HISTORIC AND DESIGN REVIEW COMMISSION

March 06, 2019

HDRC CASE NO: 2019-070
COMMON NAME: Dignowity and Lockwood Parks
ADDRESS: 701 NOLAN
801 N OLIVE ST
LEGAL DESCRIPTION: NCB 548 BLK 10 LOT ALL OF 10
NCB 539 BLK LOT P-100
ZONING: RM-4, H
CITY COUNCIL DIST.: 2
DISTRICT: Dignowity Hill Historic District
APPLICANT: Elaine Kearney/TBG Partners
OWNER: City of San Antonio
TYPE OF WORK: Park Improvements
APPLICATION RECEIVED: February 06, 2019
60-DAY REVIEW: April 7, 2019
REQUEST:

The applicant is requesting a Certificate of Appropriateness for approval to carry out various park improvements at Lockwood Park and Dignowity Park, in order to create a unified destination park that appeals to the needs of neighborhood residents and provide a location for city-wide events. The applicant is requesting approval to:

schematic plan

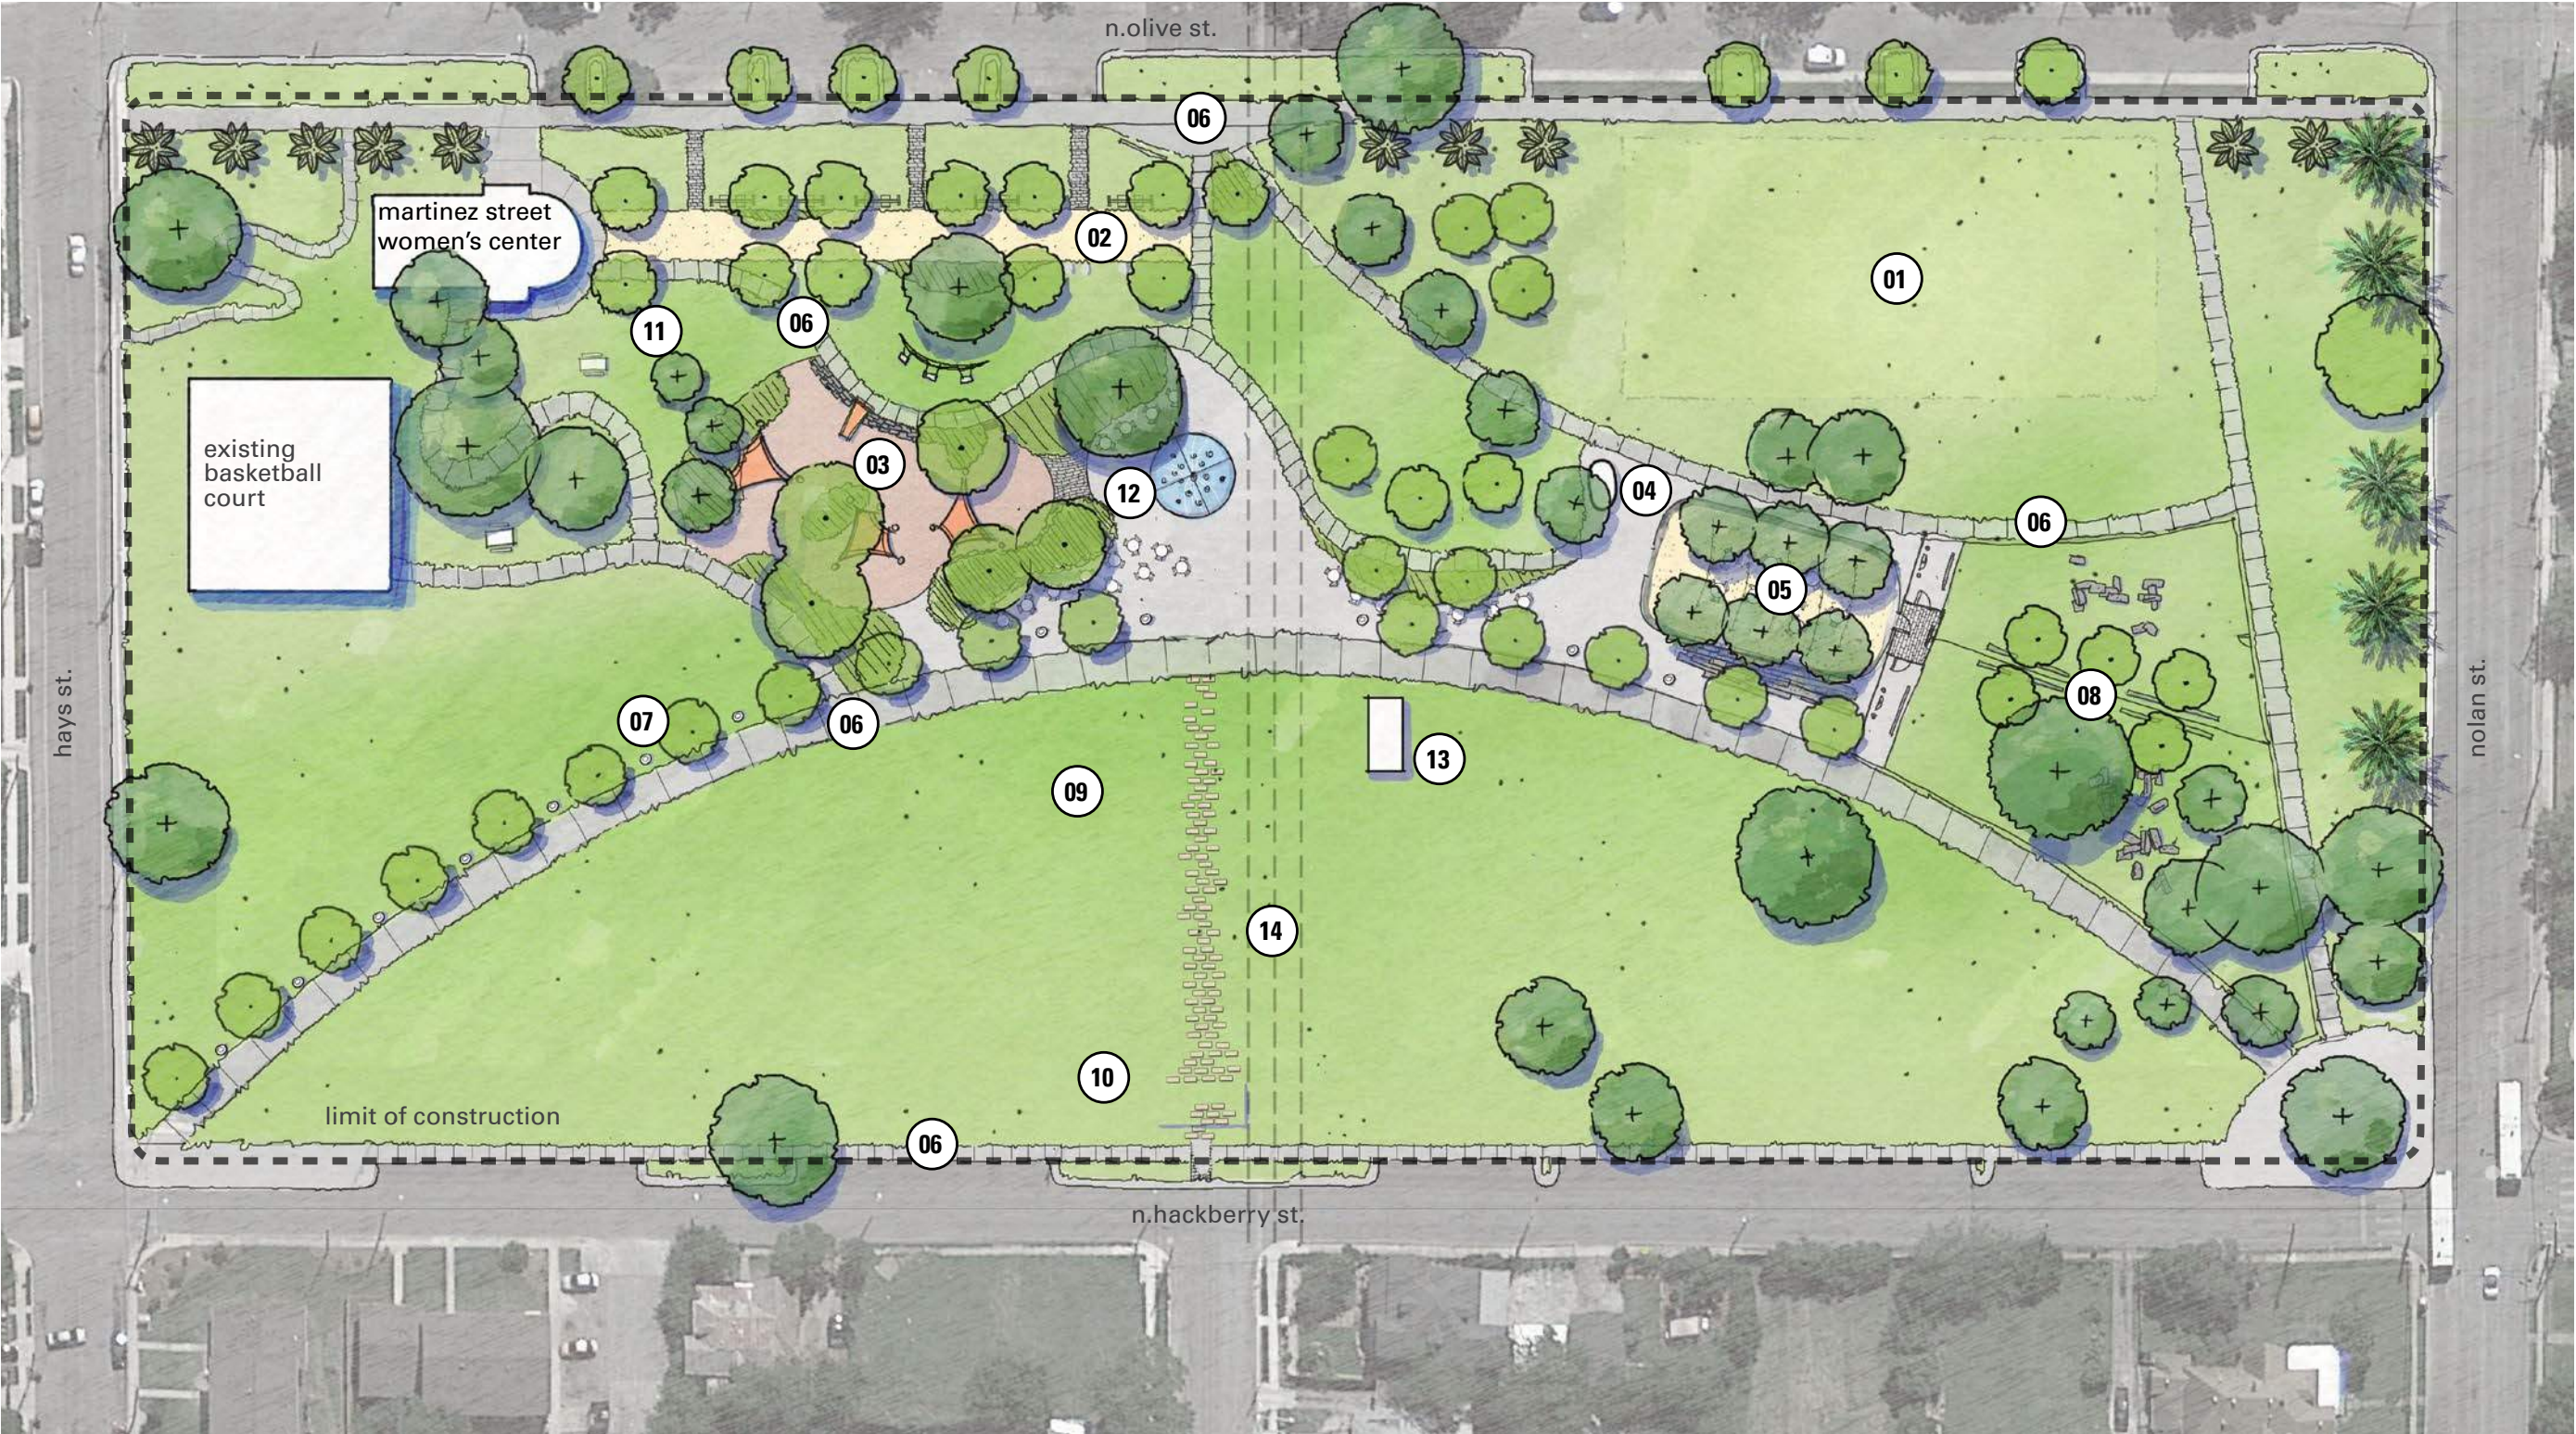
- d. RESTROOM FACILITY – The applicant has proposed to install a new Portland Loo single restroom facility. Staff finds the proposal consistent with the UDC.

- e. PARK IMPROVEMENTS – The applicant has proposed various park improvements, including the construction of a playground, restroom facilities, power infrastructure that can support large events, splashpad, fenced dog

- park, walkways, site lighting, and sidewalk improvements. Staff finds the proposal consistent with the UDC.
- f. ARCHAEOLOGY – The project shall comply with all federal, state, and local laws, rules, and regulations regarding archaeology.

PROPOSED DEMOLITION PLAN

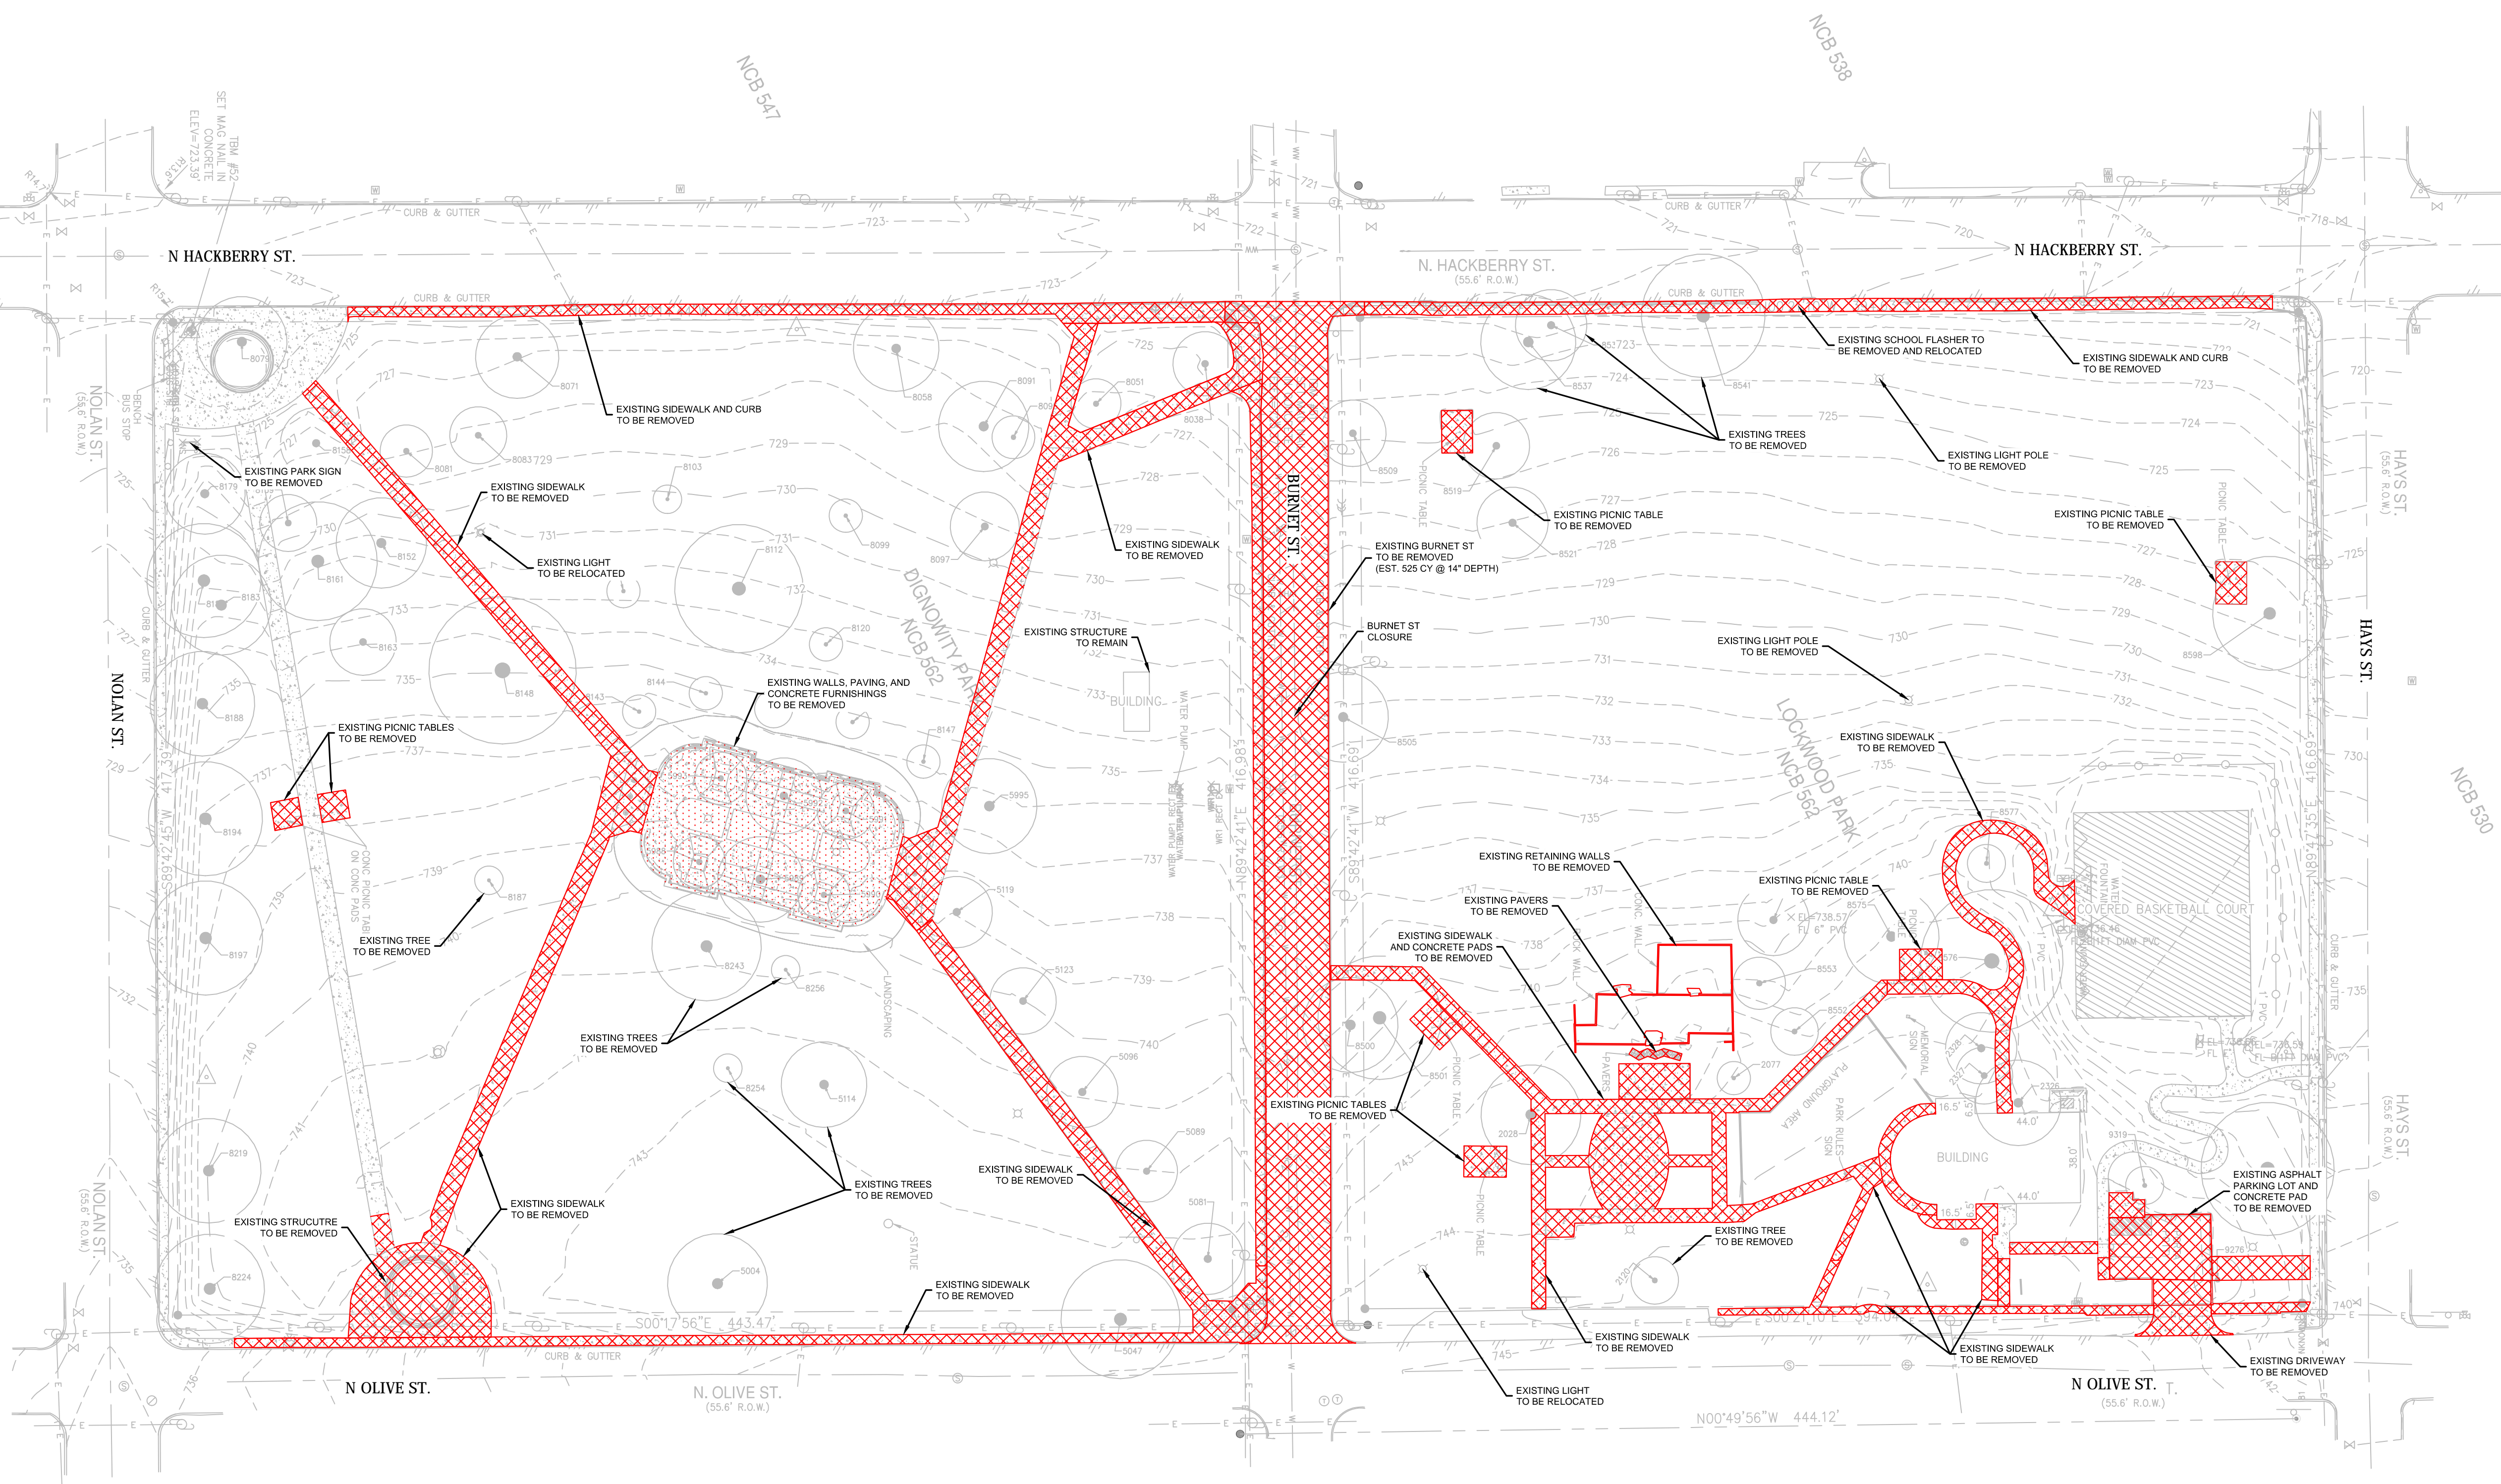
- b. STREET CLOSURE – The applicant has proposed to permanently close a segment of Burnett Street between N. Olive and N. Hackberry, including demolition of existing curbs, asphalt, and overhead electric poles in this area. By closing this segment of the street, the historic development pattern of the district will not be negatively impacted. However, staff finds that the location of the street segment could be more clearly delineated with the use of hardscape features to serve as a visual reminder of the presence of this street. Staff finds the proposal to be appropriate with the stipulations listed in the recommendation.

- c. HARDSCAPE AND LANDSCAPE MODIFICATIONS – The applicant has proposed to perform various hardscape and landscape modifications, including the selective removal of vegetation and trees and selective demolition of existing brick retaining walls, concrete site furnishings, hardscape, existing playground and exercise equipment, pole-mounted park lighting. The extent of demolition of the existing irrigation system will require further assessment. Staff finds the proposal consistent with the UDC.

- i. That the applicant more clearly dilate the segment of Burnett Street, between N. Olive and N. Hackberry, with the use of hardscape features. The applicant is required to submit updated plans that reflect this change to staff for review and approval prior to receiving a Certificate of Appropriateness.
- ii. That the applicant coordinate with the City Arborist's office to develop a comprehensive tree preservation plan and landscaping plan for final approval, and indicate where existing trees will be removed, if applicable.
- iii. ARCHAEOLOGY – The project shall comply with all federal, state, and local laws, rules, and regulations regarding archaeology.
